Subject: 19E SERIES COASTDOWN RESERVOIR
Reference:

Cent. FER 82-2

To inform the field that the passage supplying oil to the gear sprays in some coastdown reservoirs may not be completely drilled.

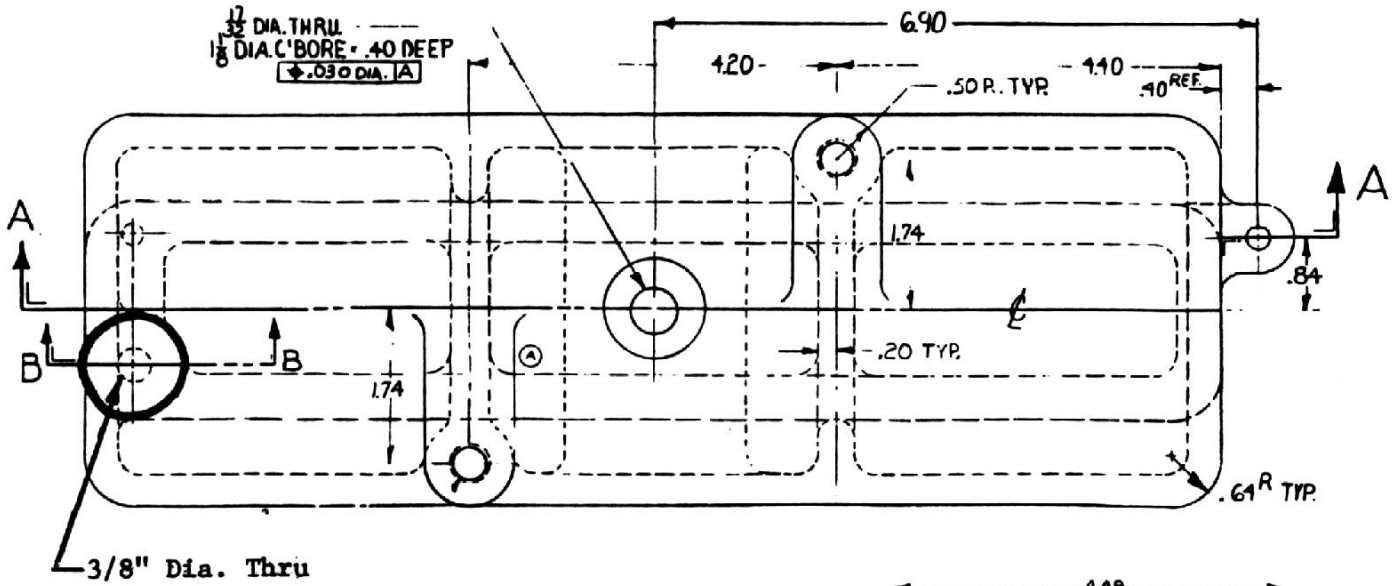
It is possible that the oil passage in the coastdown reservoir (Part No. 19EA51-1094 and 19EA41-1094) has not been drilled to a sufficient depth to provide a hole at the level through which oil is supplied to the bearing cap and into the gear spray headers.

When a machine is pumped down and the compressor opened for any reason, it is recommended that the reservoir be checked by manually running the oil pump for at least one minute. If there is insufficient oil being supplied to the gear spray headers, remove the reservoir and redrill the oil passage as shown in the attached sketches.

3/8" Dia. Thru
